SOUTH AYRSHIRE COUNCIL

LOCAL REVIEW BODY

NOTE of CURRENT POSITION

Site Address:	48 FULLARTON CRESCENT TROON SOUTH AYRSHIRE KA10 6LL
Application:	21/00776/APP ALTERATIONS AND EXTENSION TO DWELLINGHOUSE AND ERECTION OF GARAGE

3D model of revised proposals

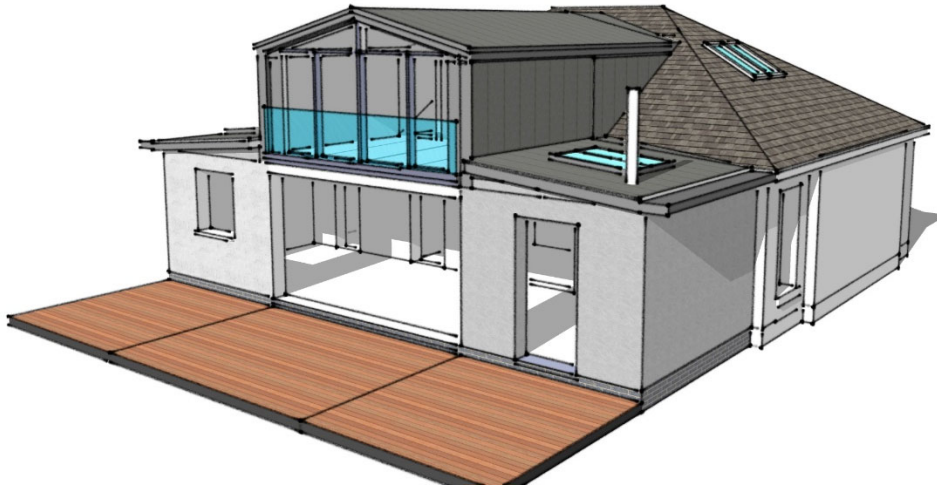
Later the same day the Council responded that the revised proposals needed to be “simplified” further and the revised proposals still could not be supported.

proposals suggested which might be acceptable

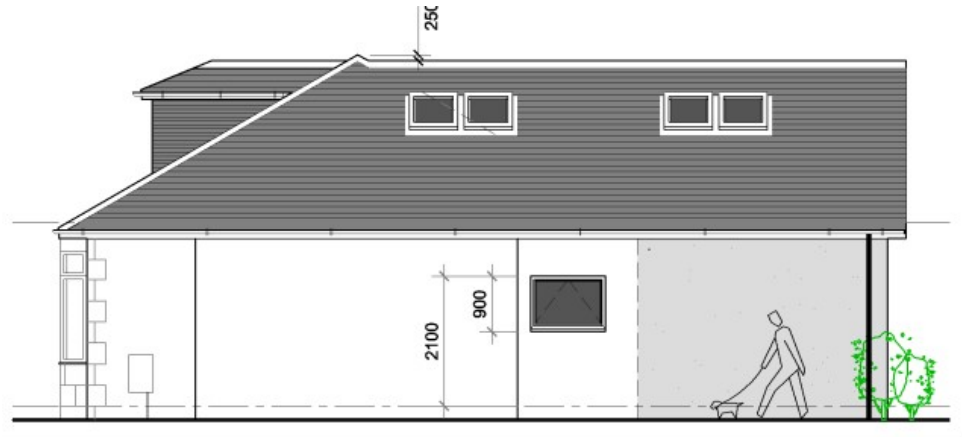
An example of something that would be acceptable was attached from the Planning Officer, taken from a similar property, and is shown below:

- Having the existing house roof and the extension roof running on the same plane would not meet the criteria of the extension being “subsidiary” to the original house, despite the notional lowering of the roof apex by 250mm and capping with a flat roof section.

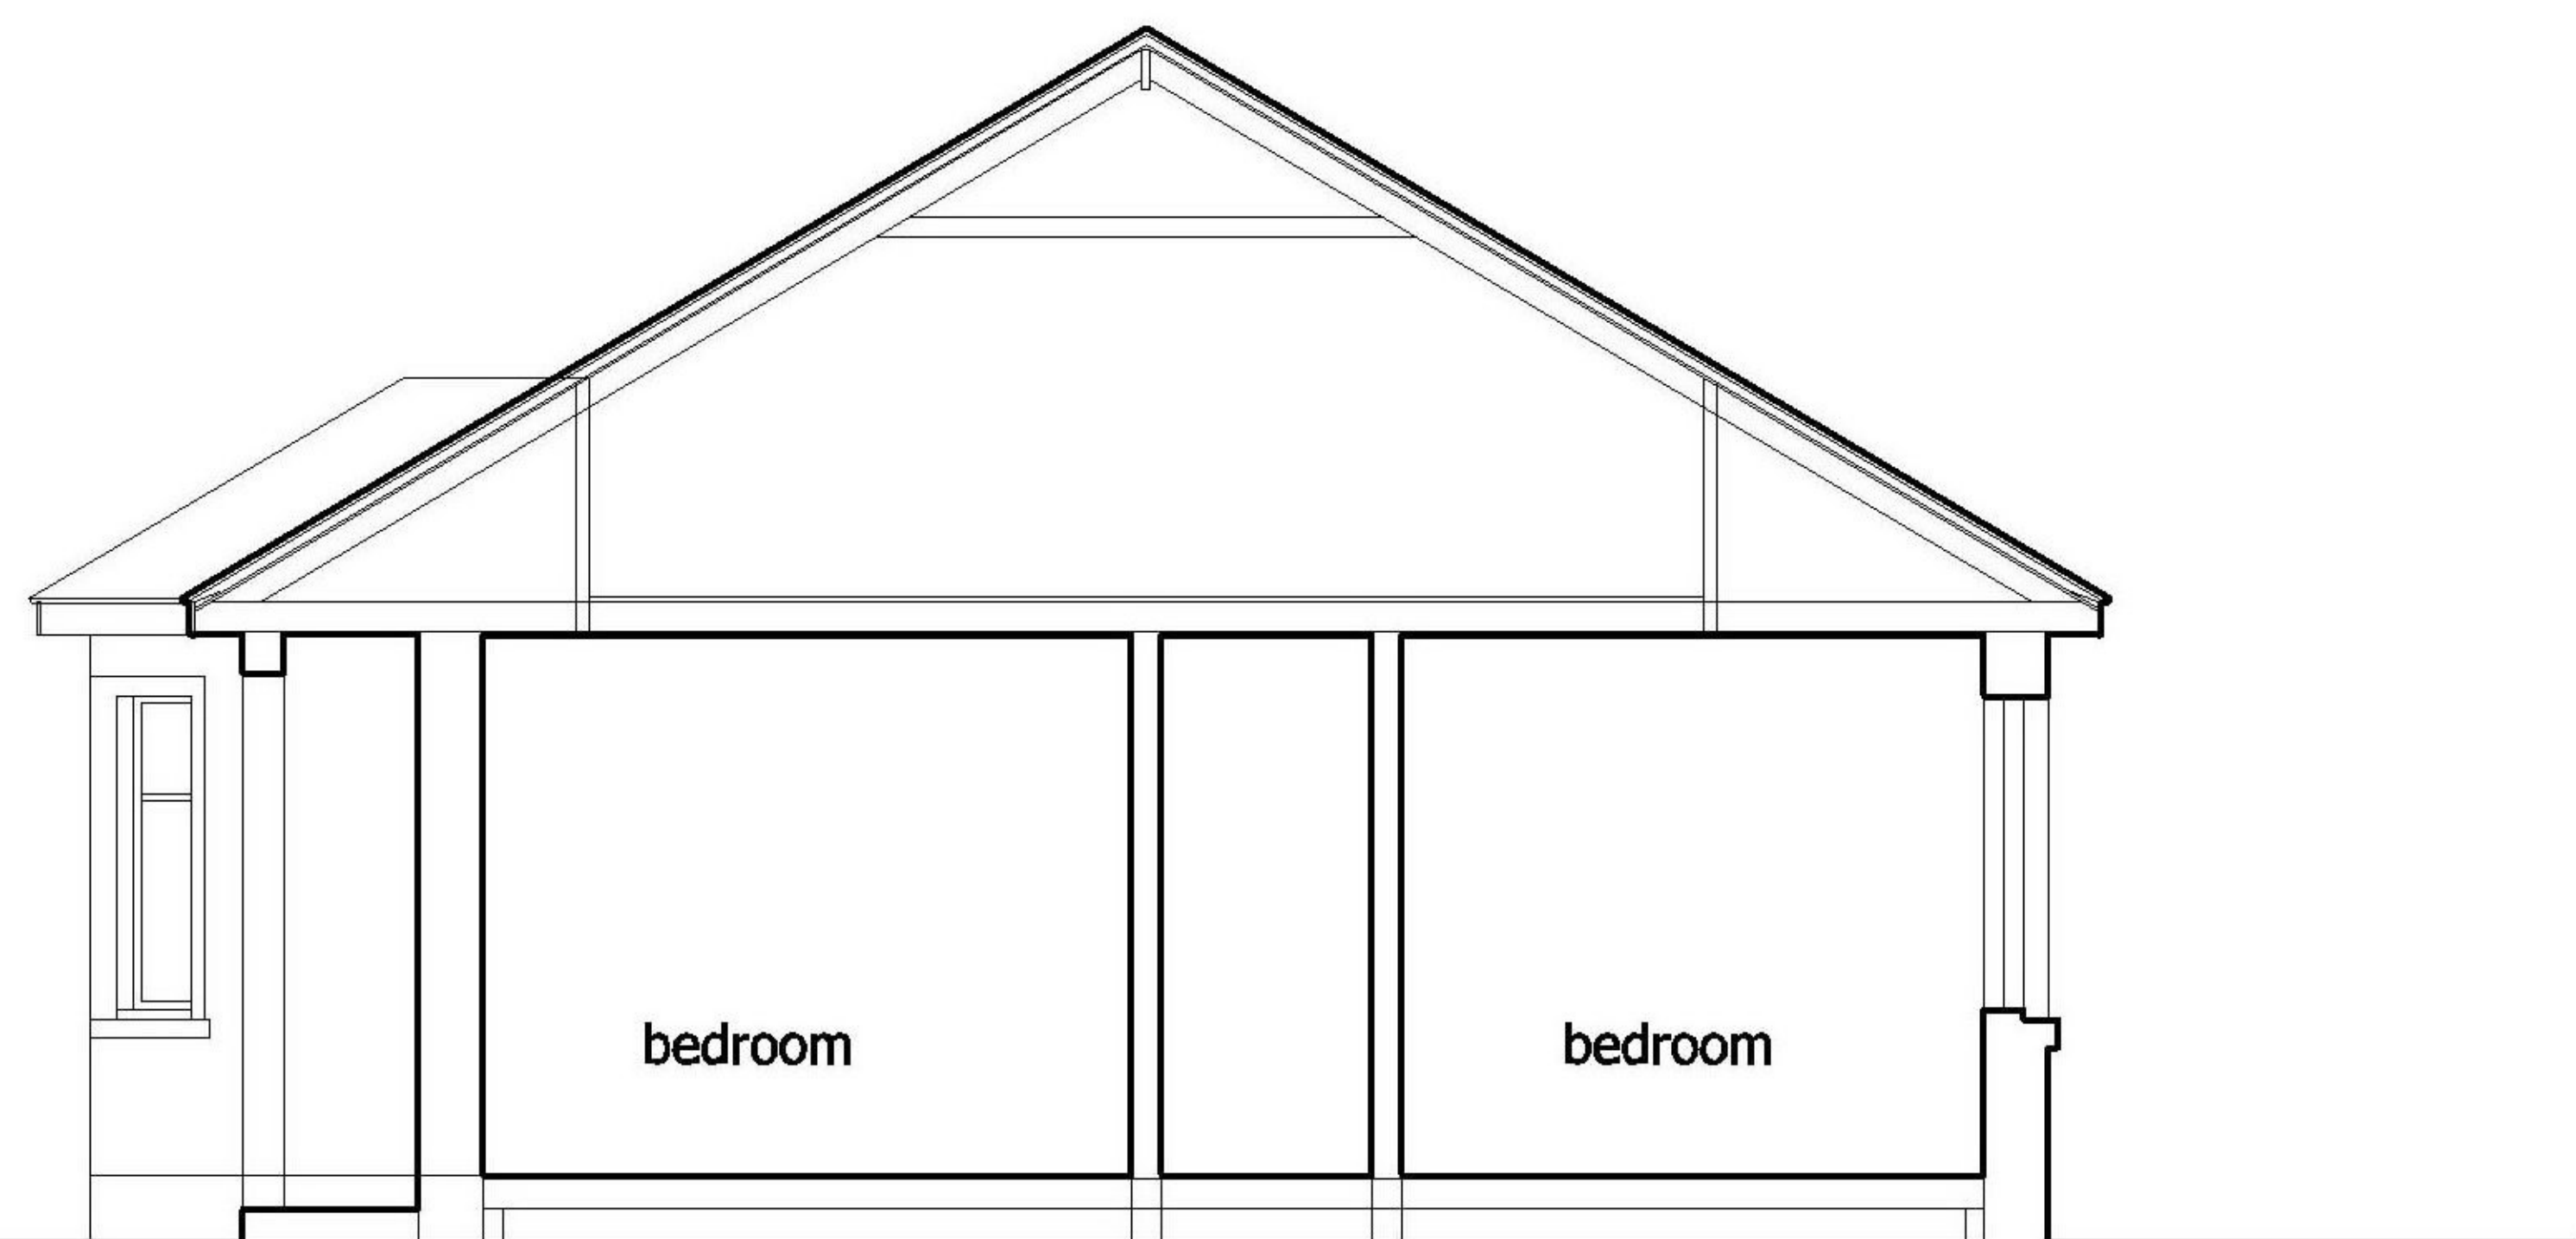
- The large, pitched roof over the full width of the extension, would surely create a much larger massing to the rear of the existing property, visible from the street?
- The rear gable would generate large unusable and wasted roof voids either side of the central higher section plus larger areas of walling.
- Having the existing house roof and the extension roof running on the same plane would not appear to meet the criteria of the extension being “subsidiary” to the original house, despite the notional lowering of the roof apex by 250mm and capping with a flat roof section.
- The large, pitched roof mass would have a negative impact on the amenity/outlook of the adjoining properties to the North and South.
